UNITED STATES OF AMERICA
NUCLEAR REGULATORY COMMISSION

SUMMARY OF FACTS, DATA, AND ARGUMENTS ON WHICH NORTHEAST NUCLEAR ENERGY COMPANY PROPOSES TO RELY AT THE SUBPART K ORAL ARGUMENT

**Millstone Nuclear Power Station, Unit No. 3
Proposed Revision to Technical Specification
Spent Fuel Pool Rerack (TSCR 3-22-98)**

FIGURE 3.9-1 Minimum Fuel Assembly Burnup Versus Nominal Initial Enrichment for Region 1 4-OUT-OF-4 Fuel Storage Configuration

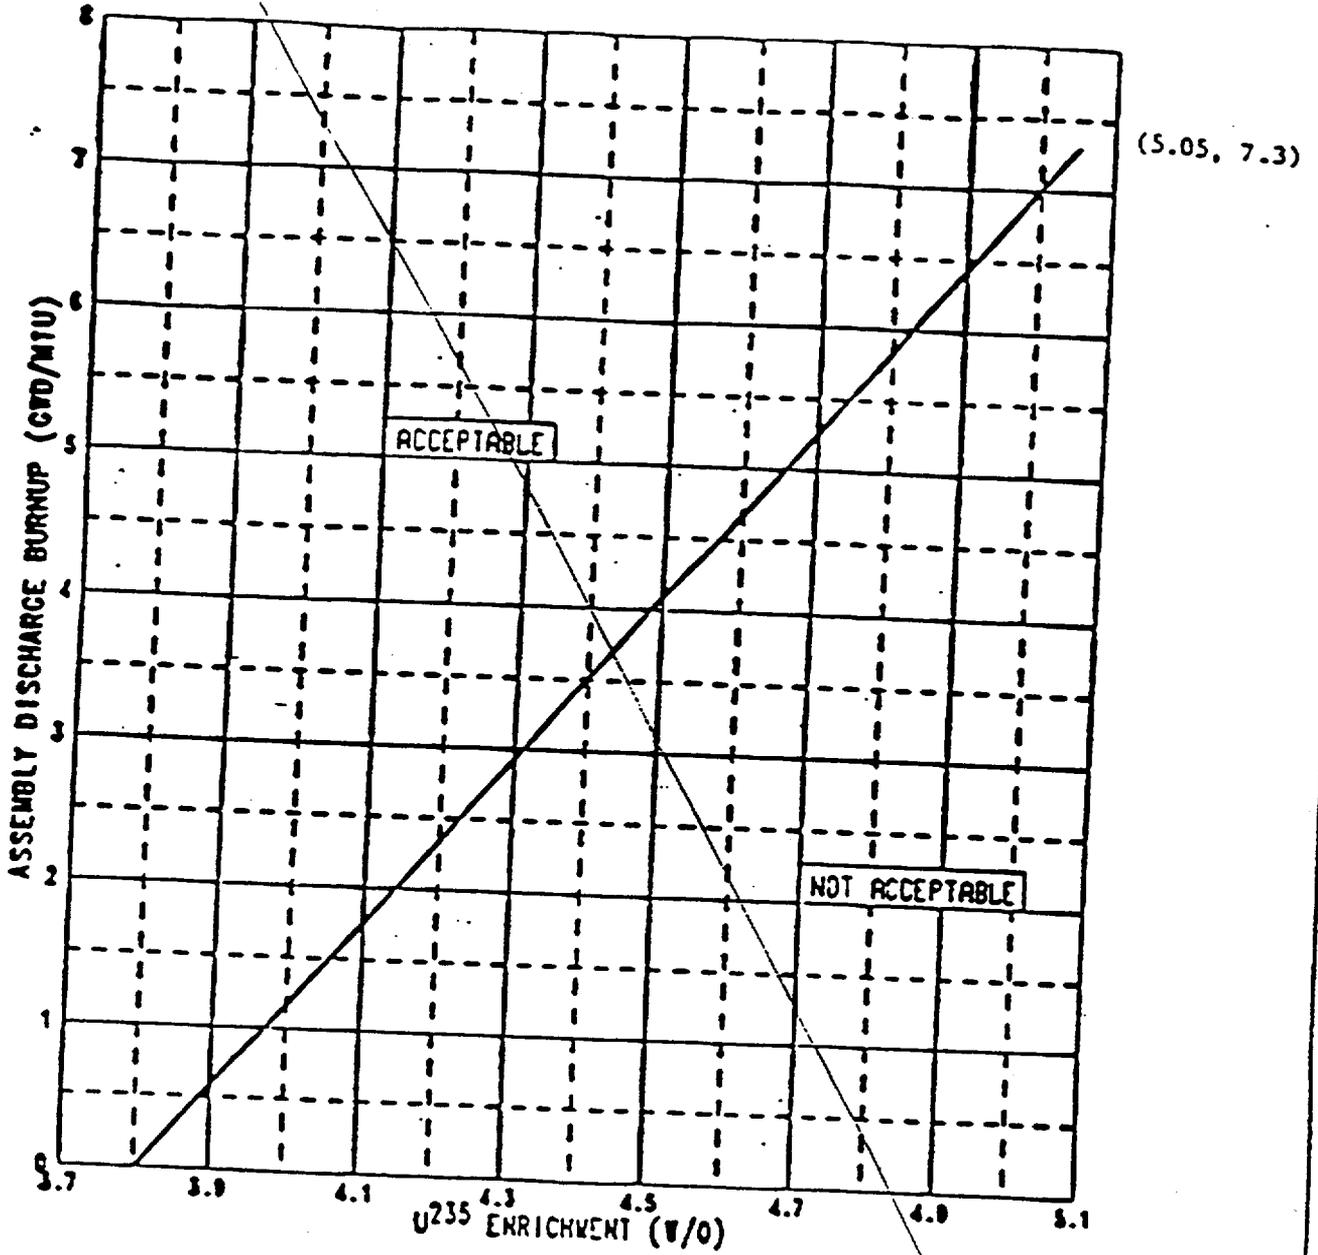
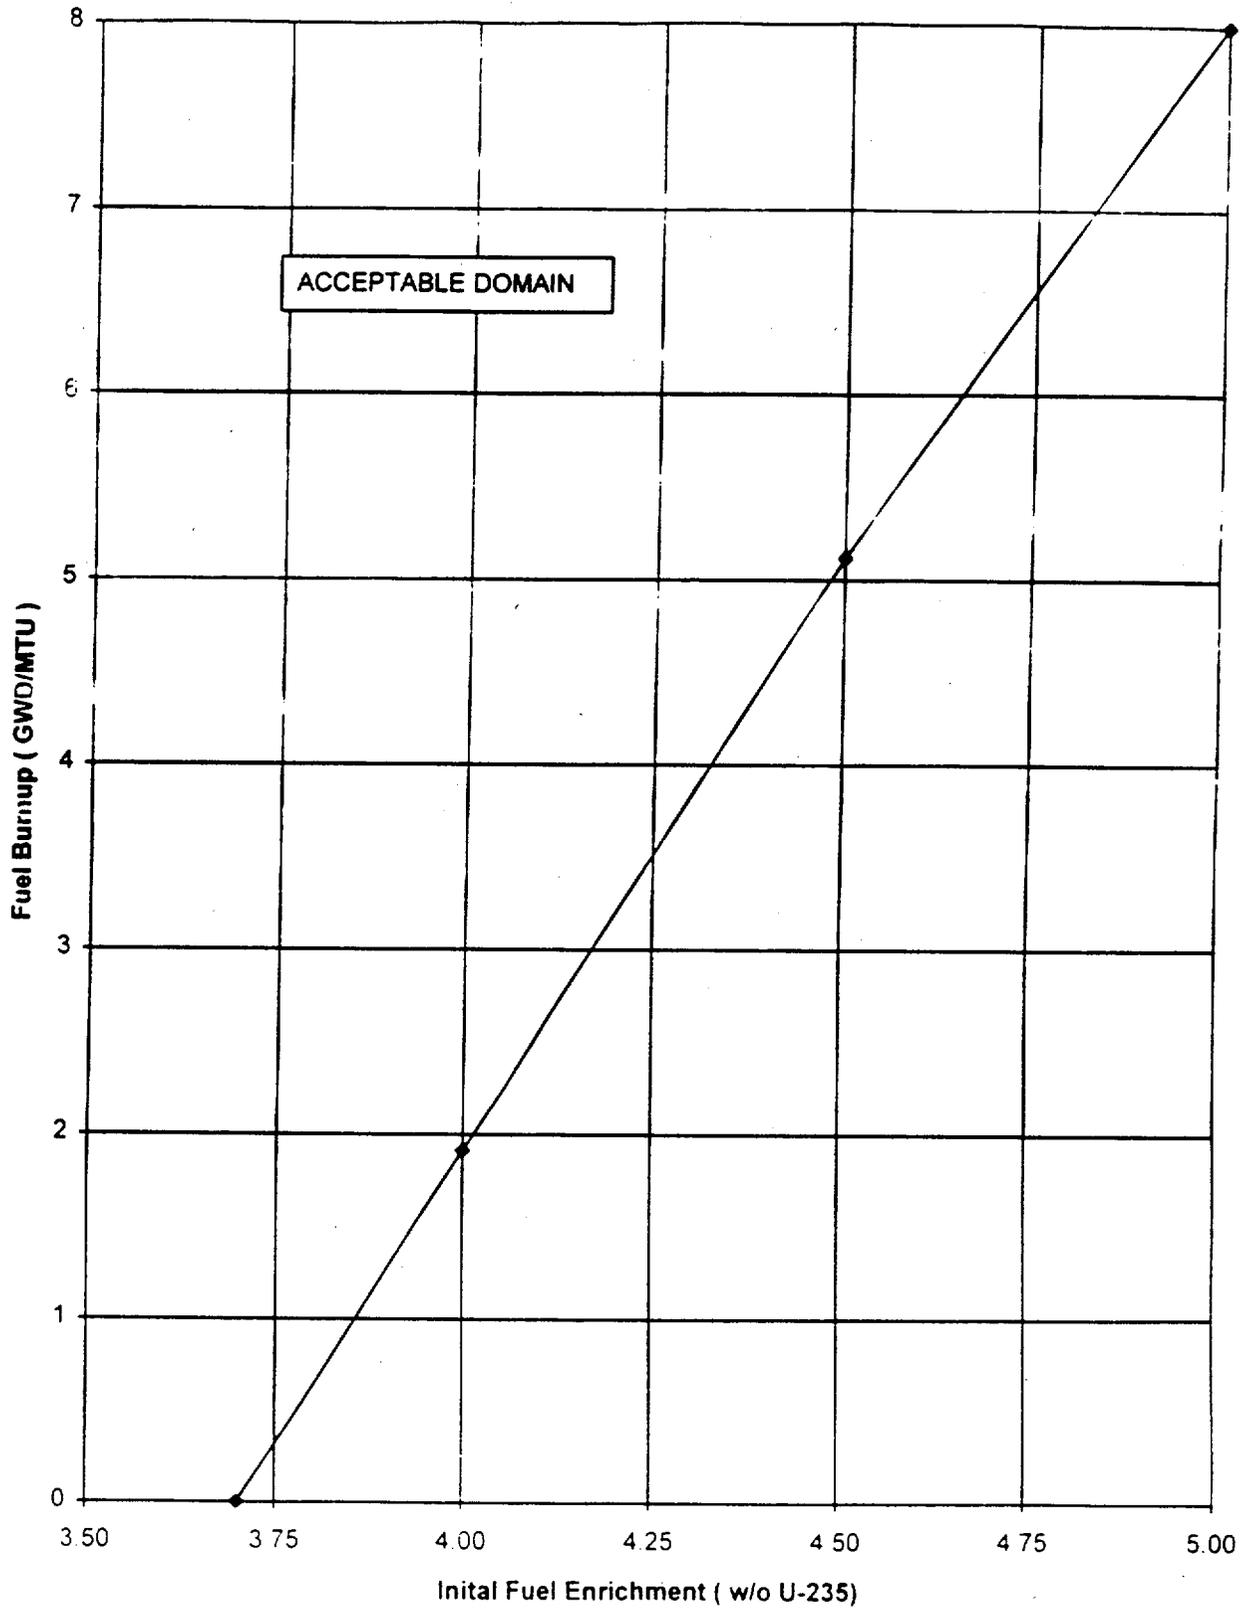
racks meet the burnup/enrichment requirements of Figure 3.9-1 (replaces old figure). Add Section 4.9.13.1.2 which requires appropriate documentation be reviewed to assure that fuel assemblies stored in Region 2 fuel racks meet the burnup/enrichment requirements of Figure 3.9-3 (new figure). Add Section 4.9.13.1.3 which requires appropriate documentation be reviewed to assure that fuel assemblies stored in Region 3 fuel racks meet the burnup/enrichment/decay time requirements of Figure 3.9-4 (new figure). Delete Sections 3.9.13c and 3.9.13d: SPENT FUEL POOL - REACTIVITY and associated Sections 4.9.13.2 and 4.9.13.3: SURVEILLANCE REQUIREMENTS. These sections deal with Boraflex integrity in response to a dropped load on a fuel rack, and in response to an Operating Basis Earthquake (OBE). The proposed reracking project eliminates all credit for Boraflex, and places burnup/enrichment/decay time requirements on fuel assemblies stored in Boraflex racks to assure k_{eff} remains less than or equal to 0.95.

Replace Figures 3.9-1 and 3.9-2 with new figures 3.9-1, 3.9-2, 3.9-3 and 3.9-4 indicating storage requirements for the proposed Regions 1, 2 and 3 fuel racks.

- 4.9.13.1a.1 Ensure that all fuel assemblies to be placed in Region 1 "4-OUT-OF-4" fuel storage are within the enrichment and burnup limits of Figure 3.9-1 by checking the fuel assembly's design and burn-up documentation.
- 4.9.13.1a.2 Ensure that all fuel assemblies to be placed in Region 2 fuel storage are within the enrichment and burnup limits of Figure 3.9-3 by checking the fuel assembly's design and burn-up documentation.
- 4.9.13.1a.3 Ensure that all fuel assemblies to be placed in Region 3 fuel storage are within the enrichment, decay time, and burnup limits of Figure 3.9-4 by checking the fuel assembly's design, decay time, and burn-up documentation.

FIGURE 3.9-2
REGION 1 3-OUT-OF-4 STORAGE FUEL ASSEMBLY LOADING SCHEMATIC

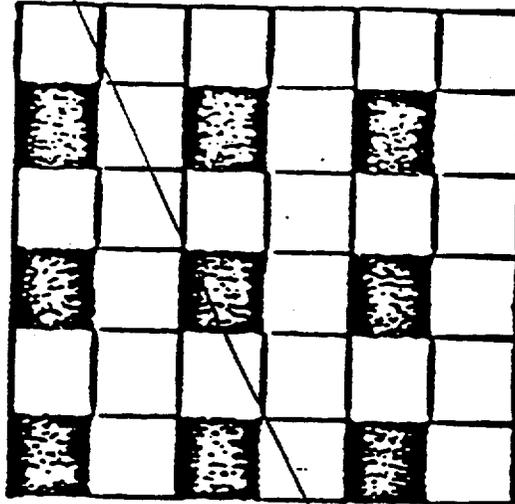
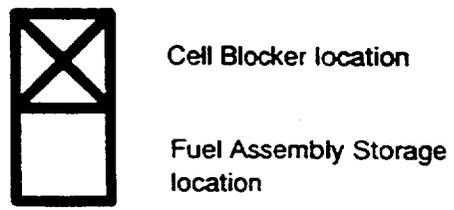
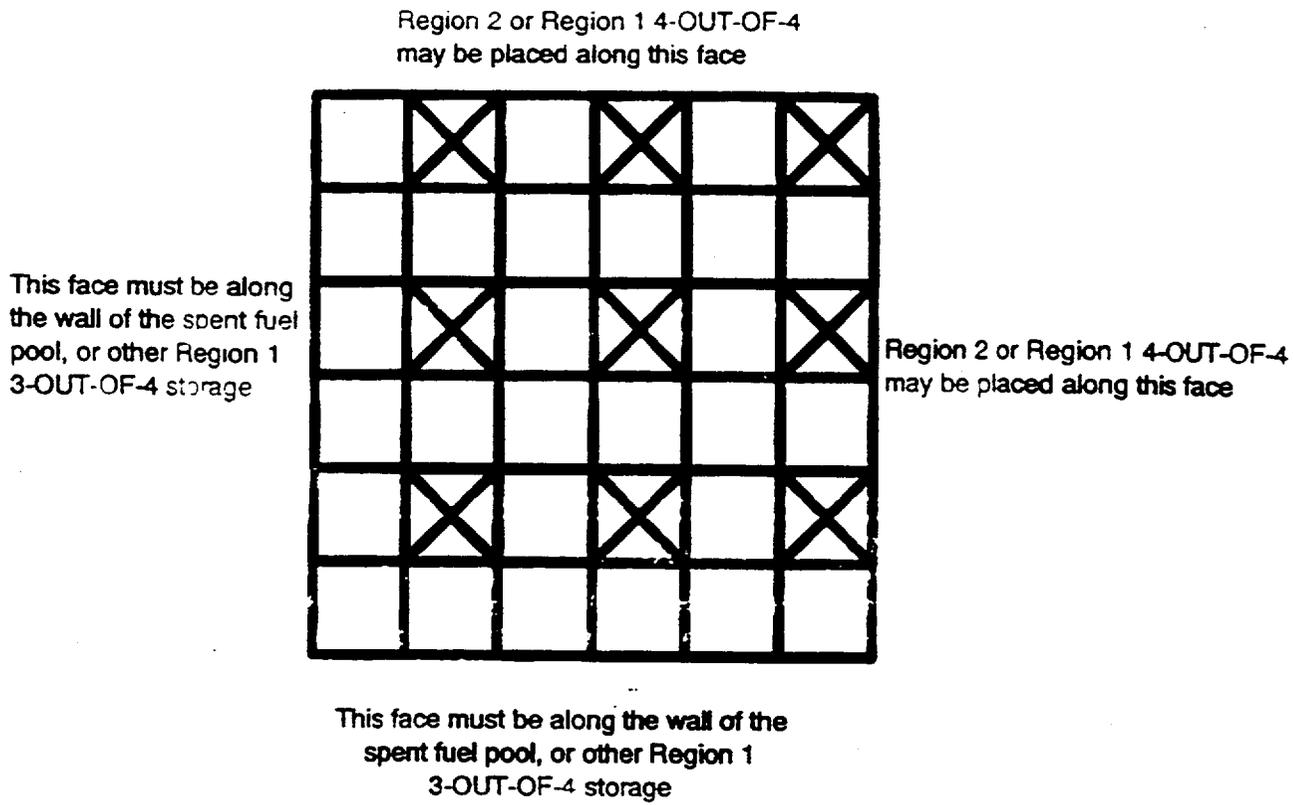
This face must be along the wall of the spent fuel pool, or other Region I modules.

Region II fuel may be placed along this face

- a. Prior to storing fuel assemblies in the STORAGE PATTERN per Figure 3.9-2, the cell blocking device for the cell location must be installed.
- b. Prior to removal of a cell blocking device from the cell location per Figure 3.9-2, the STORAGE PATTERN must be vacant of all stored fuel assemblies.
